COMBUSTION AIR CALCULATIONS

**RELEASE FOR** CONSTRUCTION **AS NOTED ON PLANS REVIEW** DEVELOPMENT SERVICES LEE'S SUMMIT, MISSOURI

6 OF 6

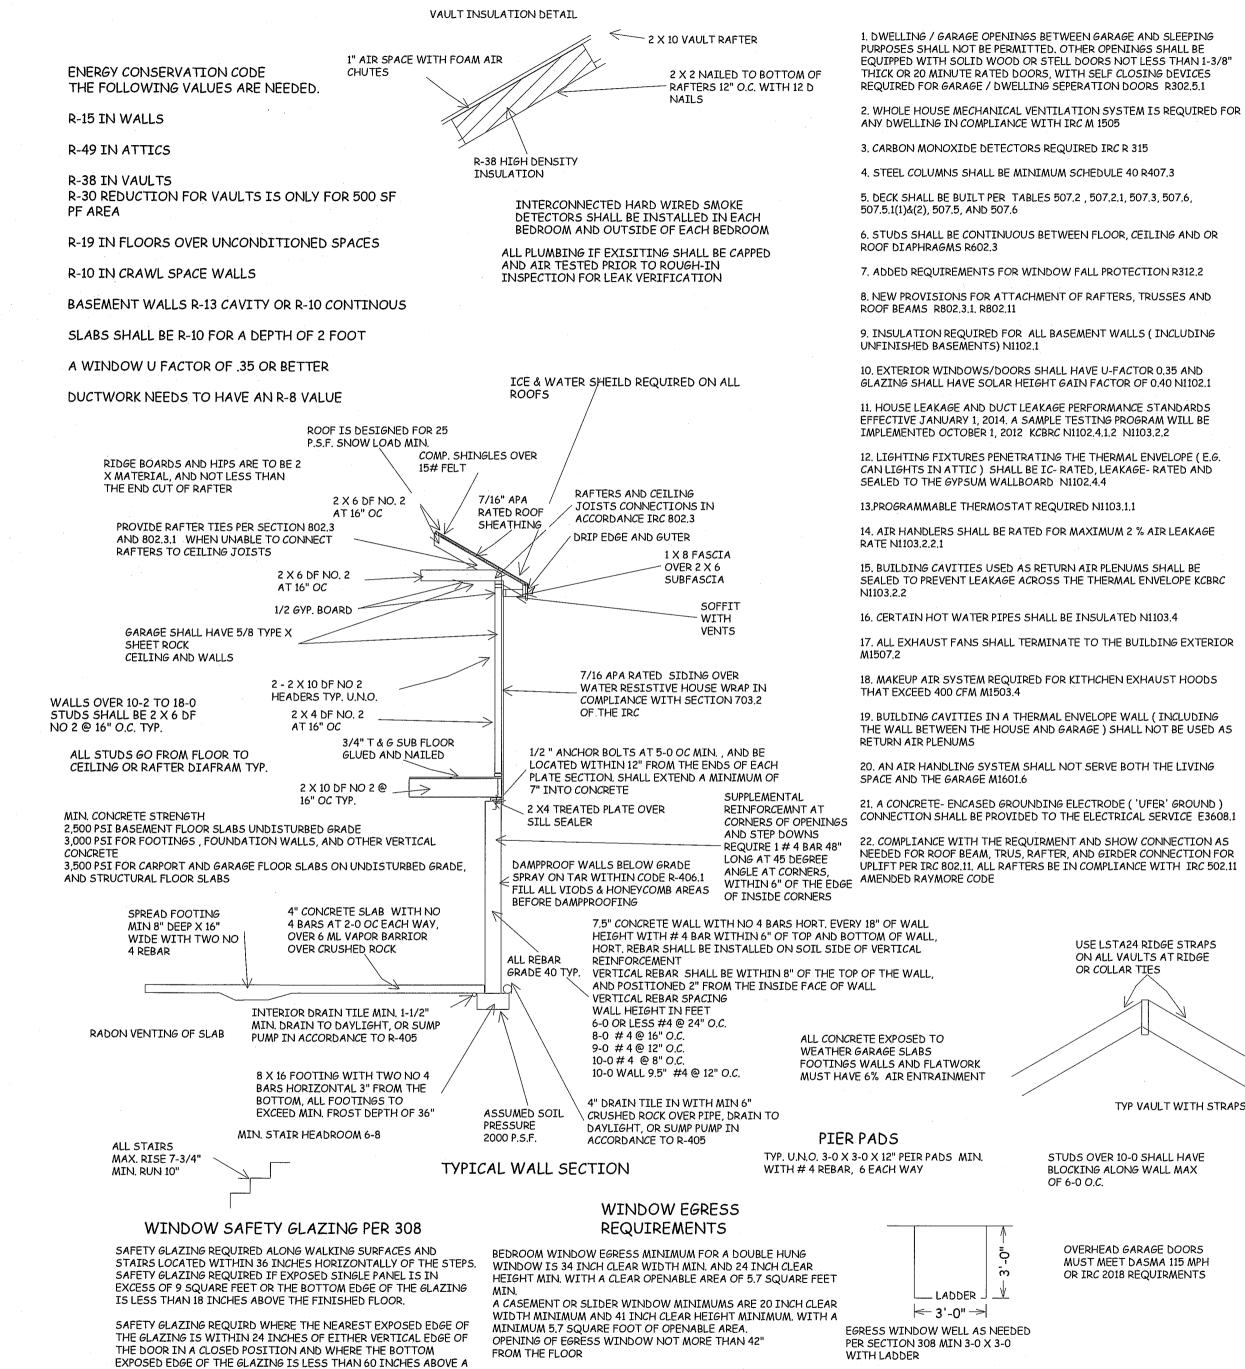
SINCE UNFINISHED AREA DOES NOT PROVIDE SUFFICIANT VOLUME FOR NORMAL INFILTRATION, INSTALL 2 METAL LOUVER VENTS IN WALL BETWEEN FAMILY ROOM AND FURNACE ROOM. ONE VENT SHALL BE @ MIN. WITHIN 12" OF THE TOP OF THE WALL, AND ONE VENT SHALL COMMENCE WITHIN 12" OF THE BOTTOM OF THE WALL. EACH VENT SHALL PROVIDE A MINIMUM FREE AREA OR 150 SQUARE INCHES (1" PER 1,000 BTU/HR) SINCE METAL LOUVERS HAVE 75% FREE AREA, MINIMUM LOUVER SIZE REQUIRED = 150/75 = 200 SQ. IN.
